TECHNICAL BULLETIN INDEX
Sorted by Bulletin Number
04/03/86

BULLETIN NO: II:1

PRODUCT: 26-4001/2 Model II

SUBASSEMBLY: AXX-0505 FDC Board Early Design (All Revisions)
AX-9033 FDC Board Late Design (All Revisions)

FIG 2

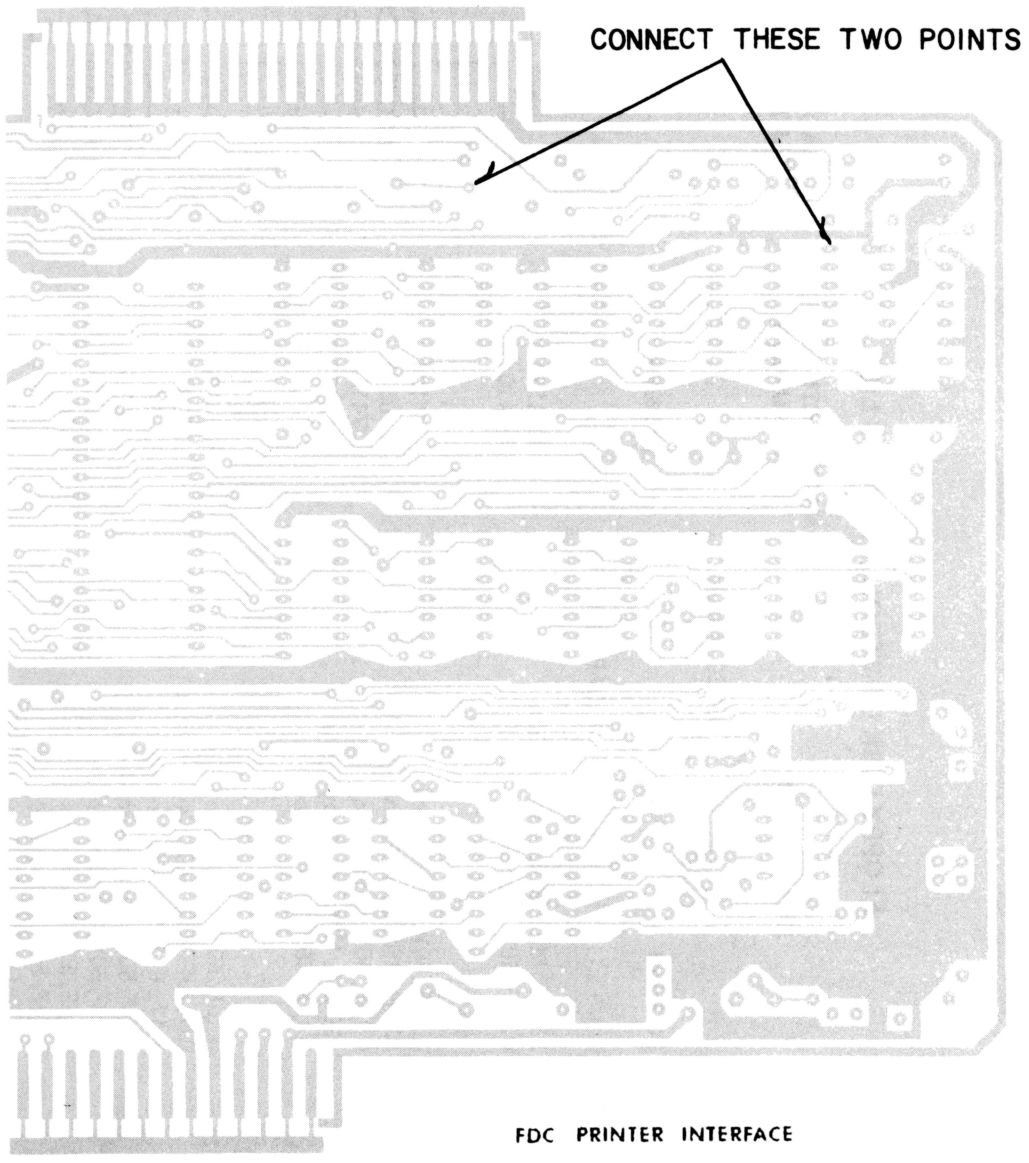
PURPOSE: To correct problem of not being able to format past Track 43.

DISCUSSION: Some early FDC boards may not be able to format past Track 43 with precomp set at the required specification of 250 nsec. This problem will occur ONLY with the SY1791-02 FDC chip (not the FD1791-02 FDC chip) because the EARLY pulse ends slightly sooner on the SY1791-02. This could lead to a double pulse being picked off the shift register. To correct this problem the data out is tied to the RESET of the shift register. As soon as the data triggers the one-shot, it then clears the shift register, preventing double data pulses (Refer to Figure 1).

PROCEDURE: On unmarked, Rev A, or Rev B boards make sure the "one shot" modification has been installed (Refer to Technical Bulletin II:9), or that long jumpers are installed on the back of the board running to U37. Disregard this step on Rev C and D boards as they have this modification incorporated into their circuitry. On ALL revisions of the current board with a SY1791-02 FDC chip installed, add a jumper wire on the back side of the board from U1 pin 1 to the trace connected to TP10 (Refer to Figure 2).

Figure 1

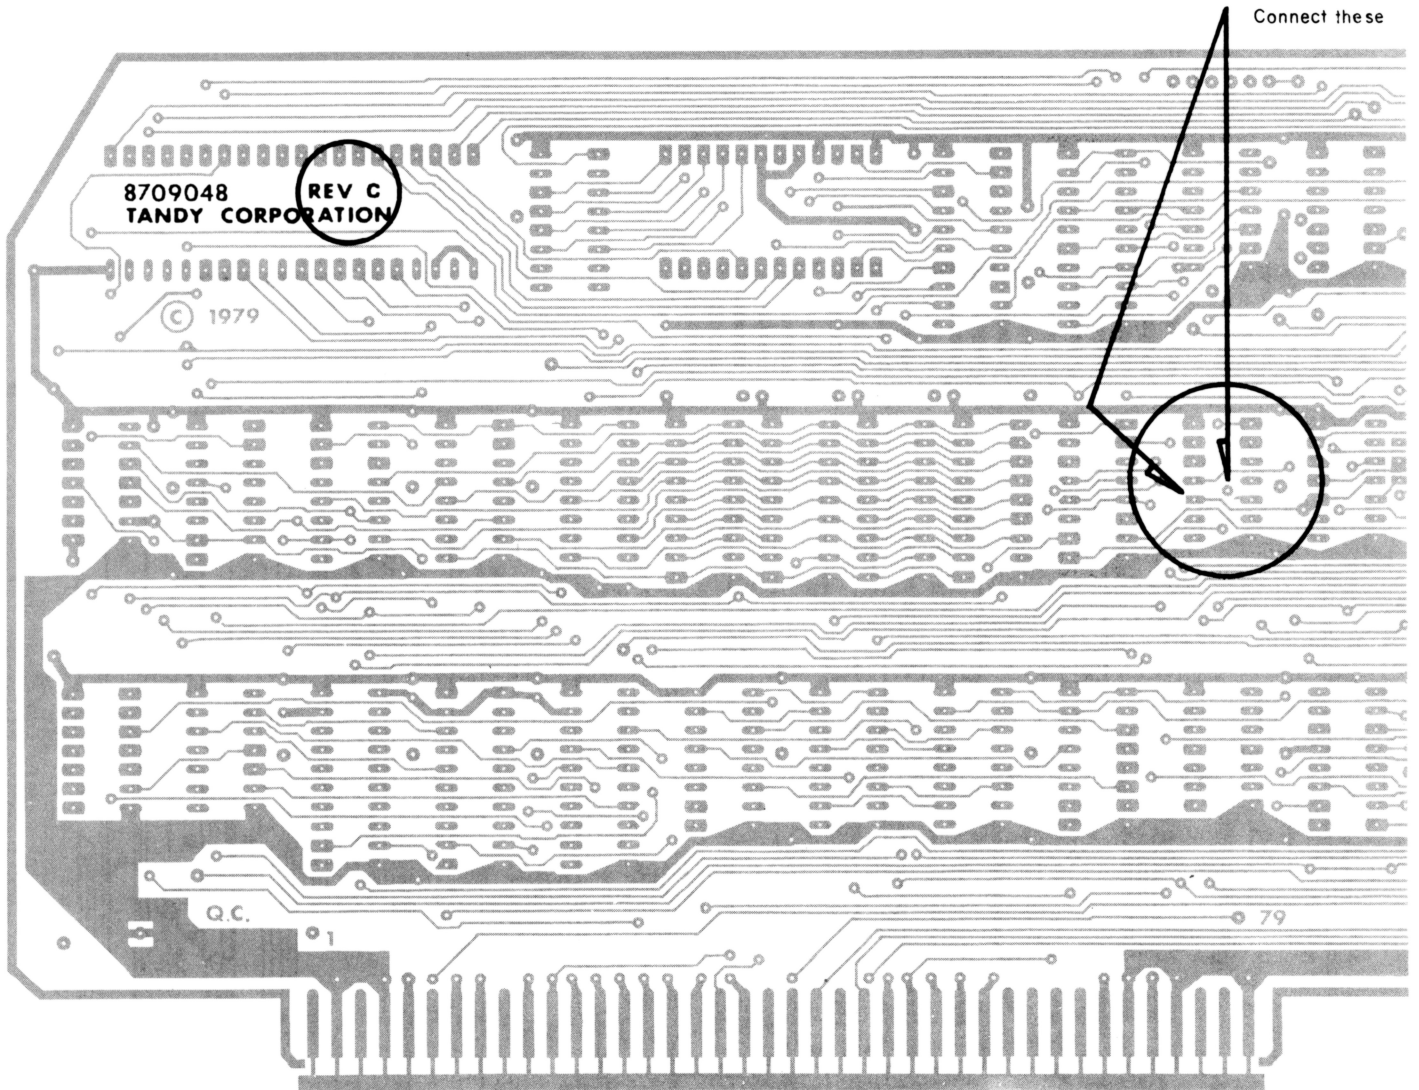
PURPOSE: To correct unexplained keyboard entries and/or machine lockup.

DISCUSSION: On Rev C VDG boards made by Lika there is a trace missing to the clear line on the latch (U17) that generates KBIRQ*. This can generate random interrupts that may or may not be fatal. To correct this problem a jumper is added to correct the missing trace which is a pullup to the clear line of U17. To identify the board as being manufactured by Lika, look for the Rev C marking on the solder side of the board under the 6845 chip and by LEI etched also on the solder side the crystal. This is the ONLY board to which this fix applies.

PROCEDURE: On the solder side of the board there is a feedthru located beneath the middle of U17 that is not connected to anything. Run a short piece of wire from that feedthru to U17 Pin 10 (Refer to Figure 1).

Figure 1

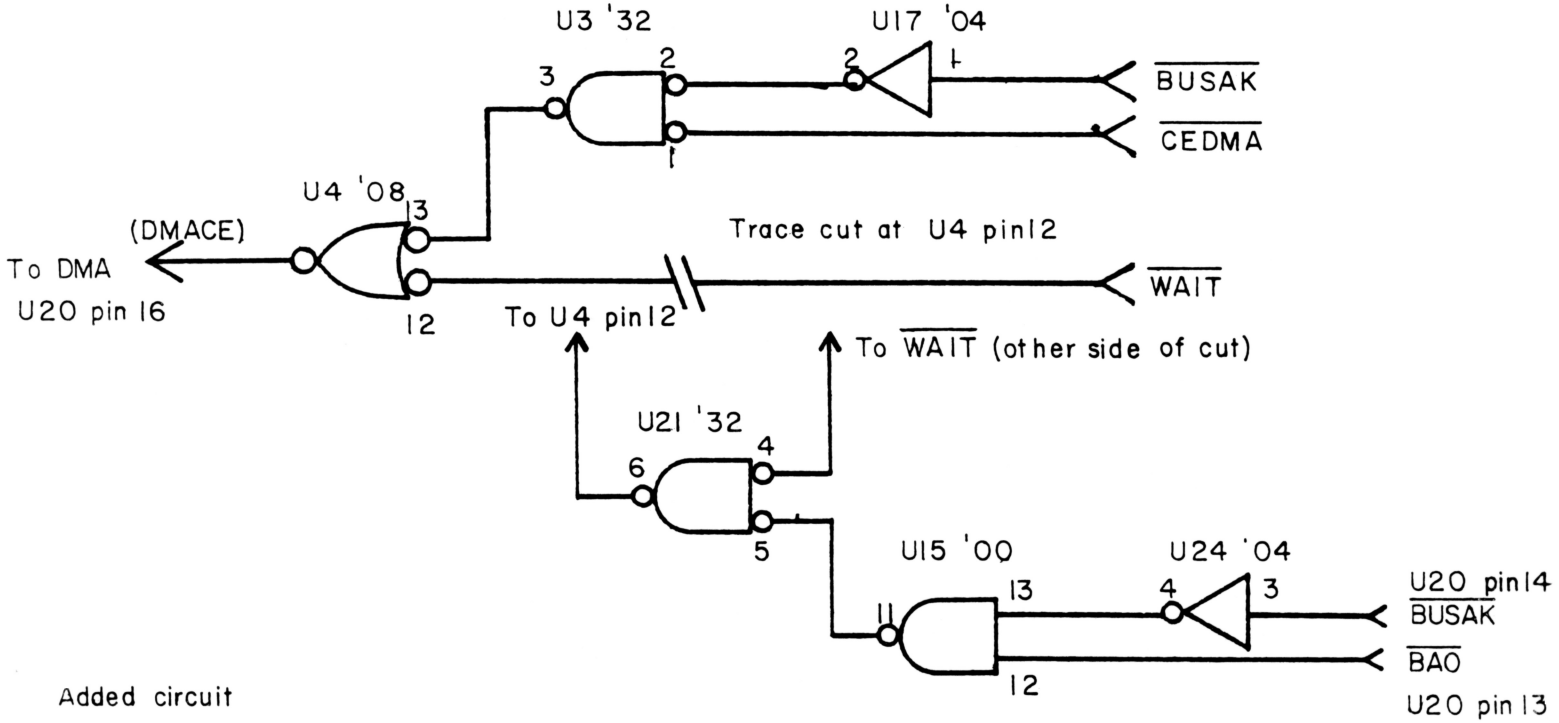
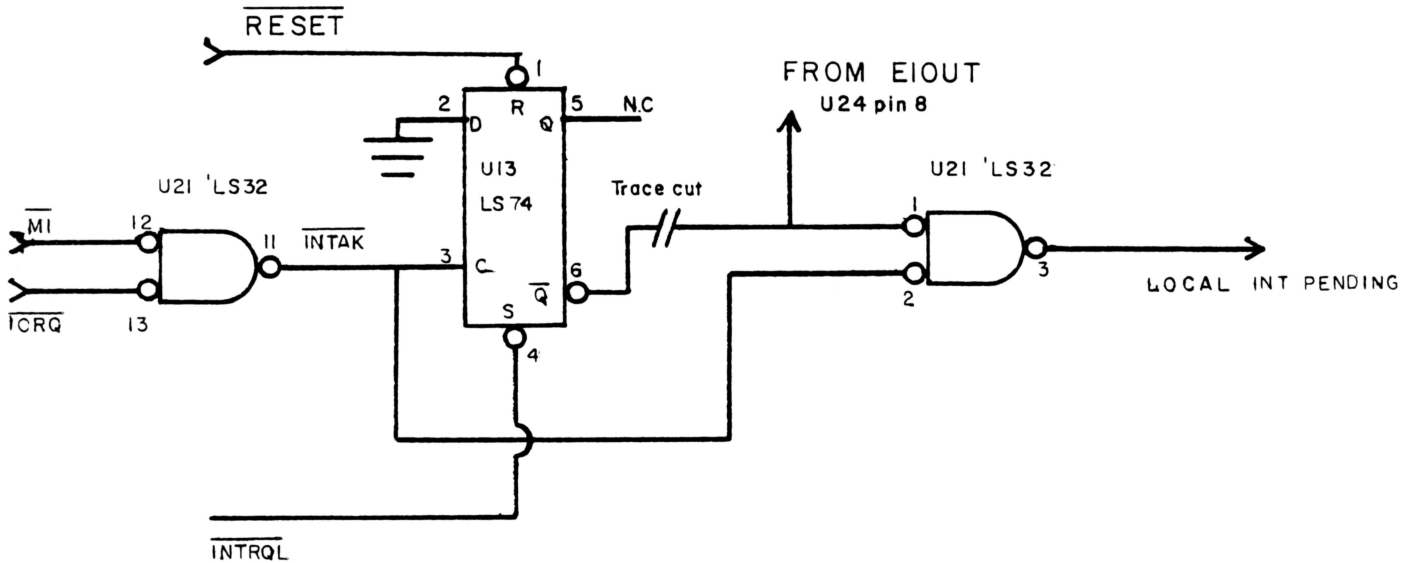
PURPOSE: To outline enhanced DMA modification procedure.

DISCUSSION: This modification is the same as the Hard Disk modification except it does not include anything unique to the Hard Disk such as the Boot ROM. Rev A,B, and C boards are the ONLY CPU boards to which this modification applies. DO NOT perform this modification on Rev D and later boards as they have this modification incorporated into their design. Refer to Figures 1 and 2 for schematic changes affected by this modification.

U21 pin 1 to U24 pin 8
U4 pin 12 to U21 pin 6
U21 pin 4 to WAIT* (the first feedthru after the cut at U4 pin 12)
U21 pin 5 to U15 pin 11
U15 pin 12 to U20 pin 13
U15 pin 13 to U24 pin 4
U24 pin 3 to U20 pin 14

Figure 1

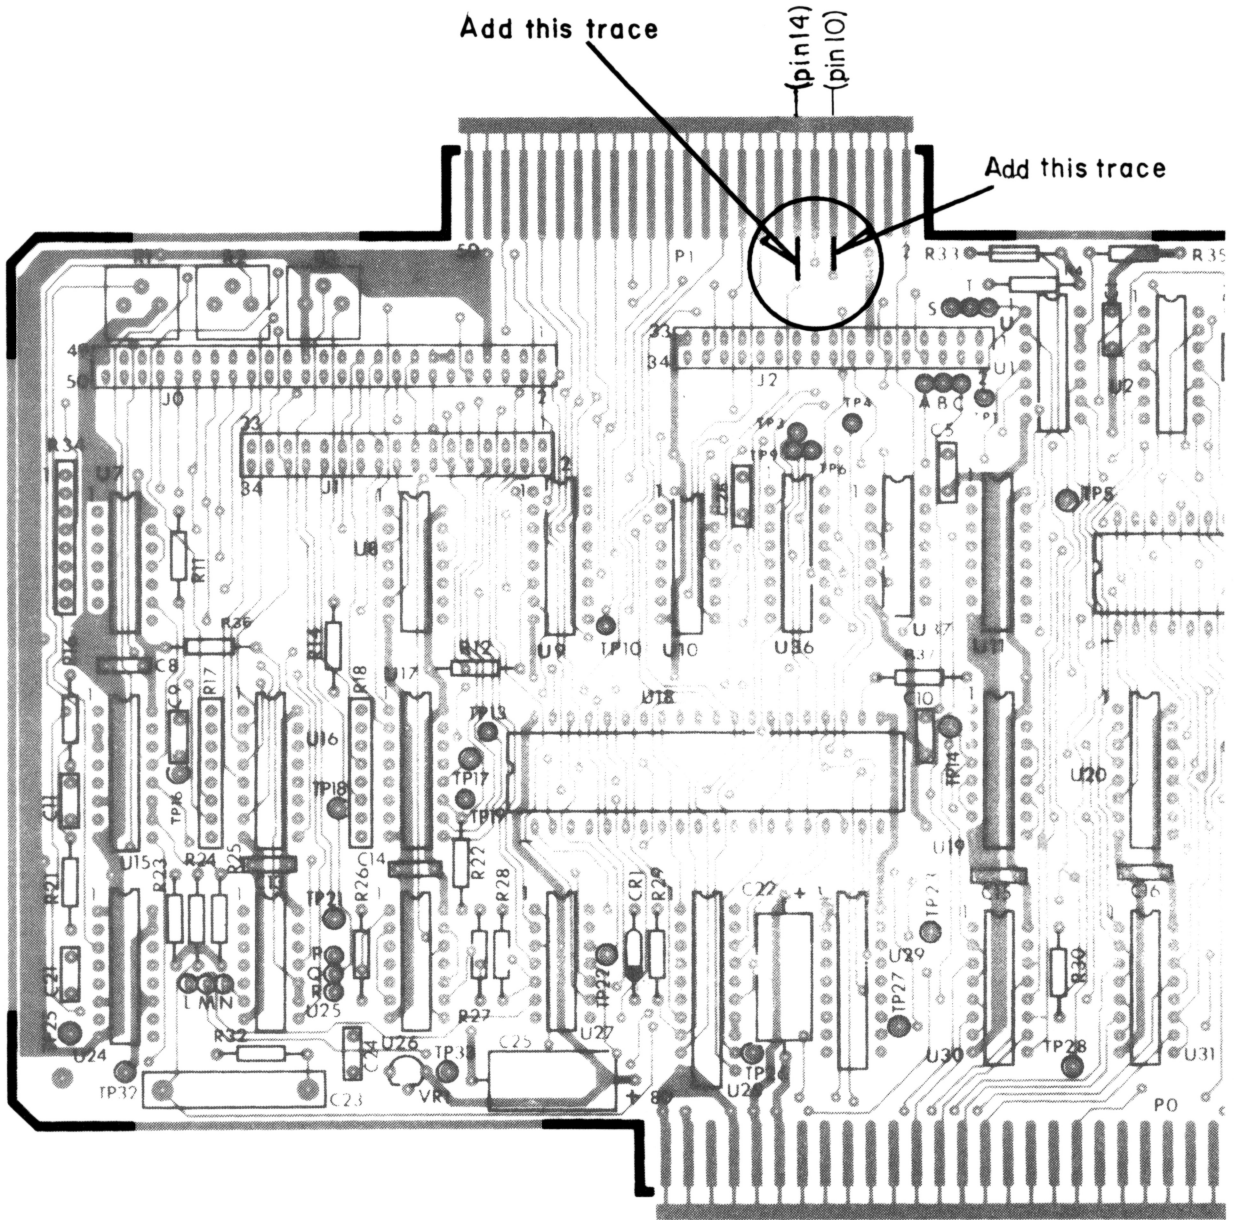
DISCUSSION: The trace that supplies the side select signal to the external drive connector on the Late Design FDC board (Rev Blank) is missing. Also, on some boards the trace that supplies the TWOSIDE* signal from the external drives to the FDC board is not present. Without these traces double sided drives cannot be used externally with the computer and will cause a problem with some diagnostics.

PROCEDURE: Refer to Figure 1 for the location of these traces. Run a jumper from pin 14 of connector P1 to the feedthru on the PCB that is directly in from the connector. Also run a jumper from pin 10 of connector P1 to the feedthru that is directly in from the connector.

Figure 1

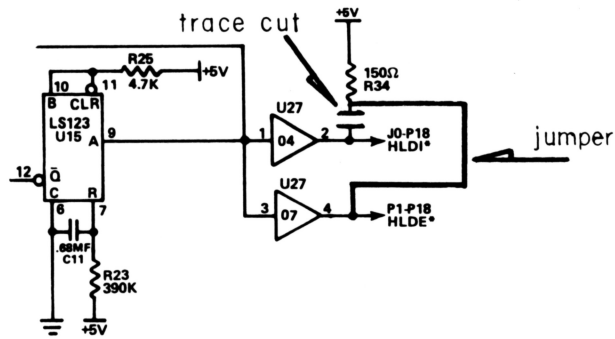
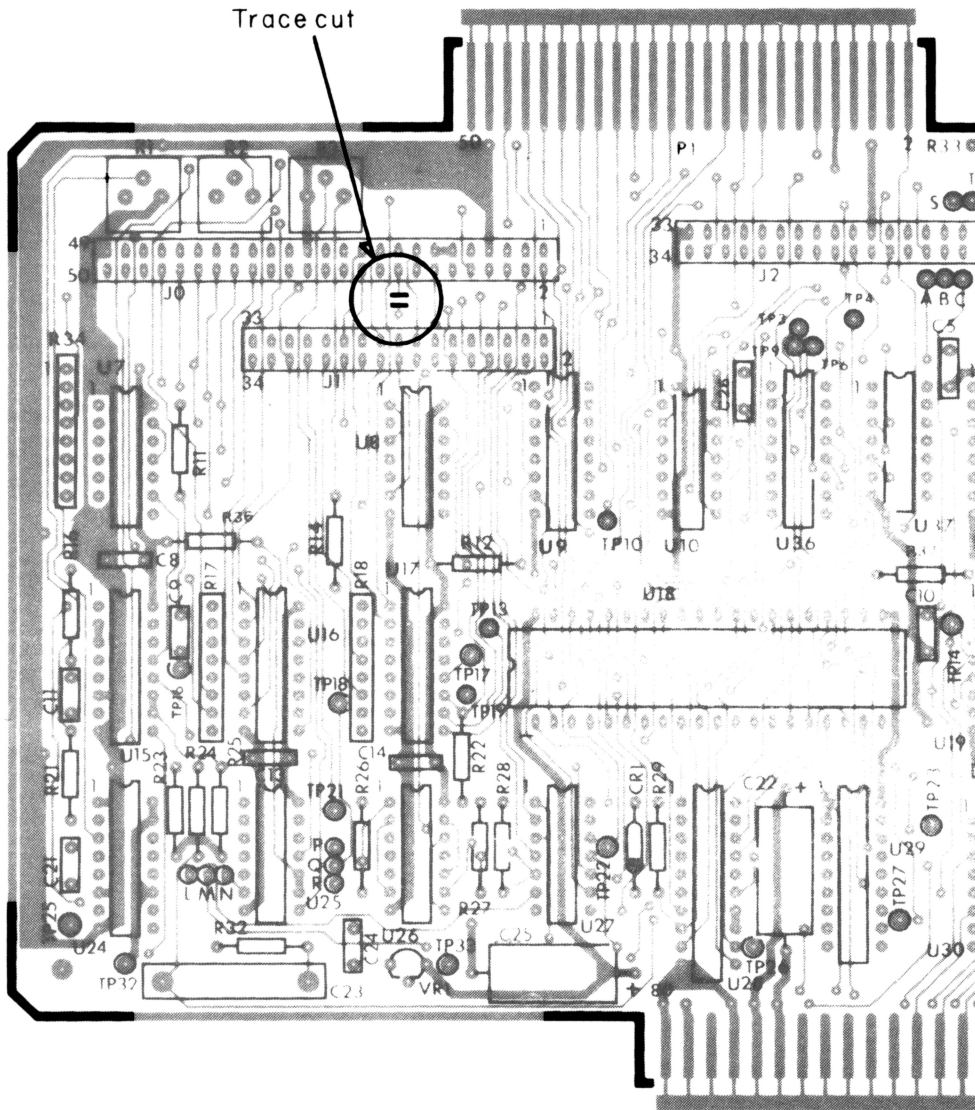
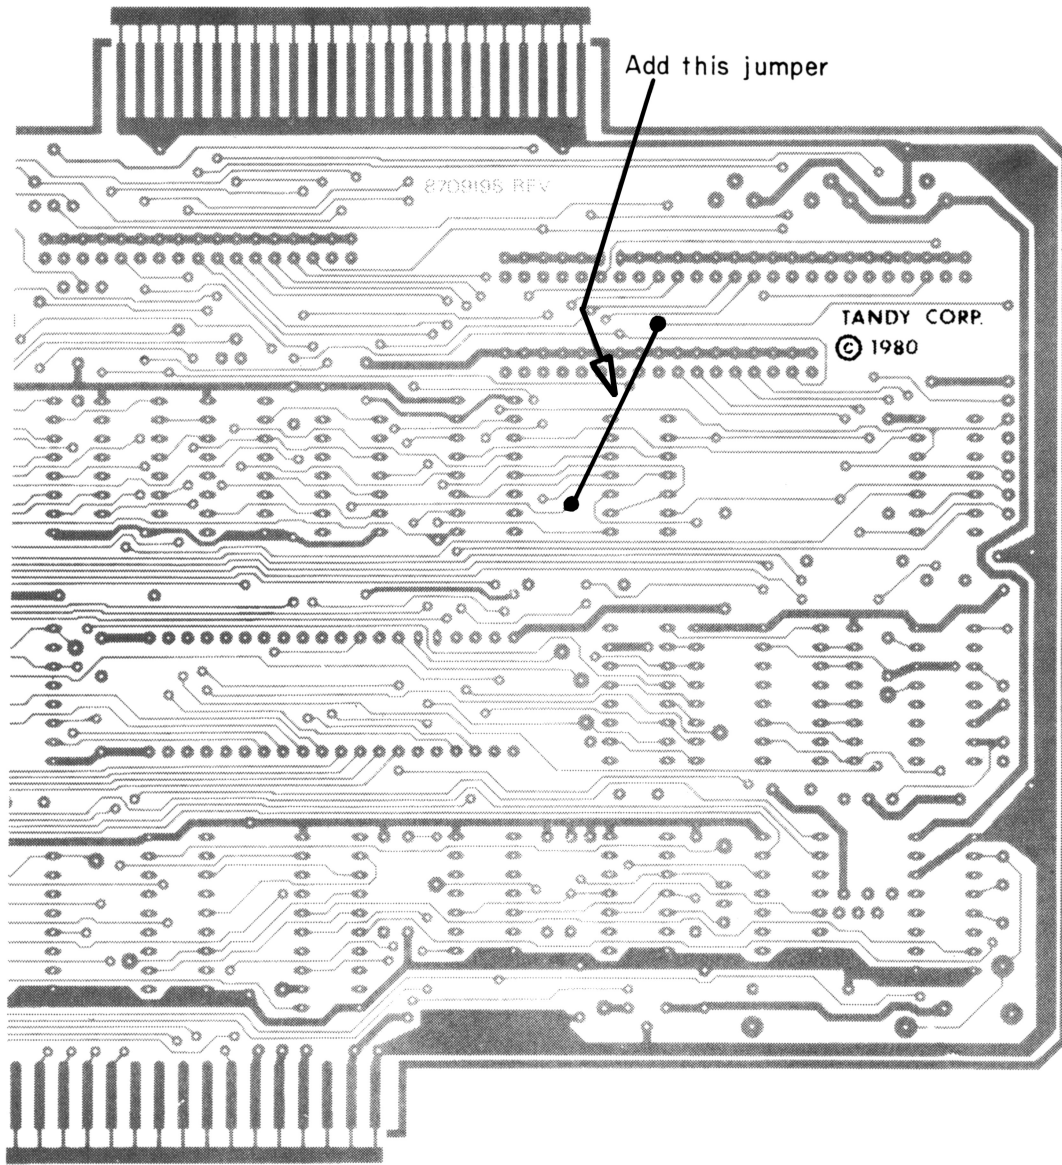
PURPOSE: To correct Head Load termination on FDC board (Late design/Rev Blank).

DISCUSSION: On the redesigned FDC board (Rev Blank) there is a pullup resistor on the Head Load signal for internal drives, but there is none for external drives. With the Model II the internal drive has Head Load termination on the board but the bay does not. With the FDC board (Redesign) this means that the internal drive has double Head Load termination while the external Head Load signal has no pullup. To correct this problem we eliminate the internal Head Load signal on the FDC board and use its pullup for the external Head Load signal (Refer to Figure 1).

1. On the componet side, cut the trace that goes to pin 18 of J0 (the 50 position pin header connector) RIGHT AT the connector so that the feedthru can still be used on the reverse side to go to the external head load signal (Refer to Figure 2).
2. Turn the board over to the solder side and solder a jumper from the feedthru referenced in step 1 (this is the pullup resistor line) to the feedthru between U8 and U9 that is closest to pin 8 and 9 of U8. This feedthru is the Head Load external signal external signal and goes over to U10 on the solder side of the board (Refer to Figure 3).
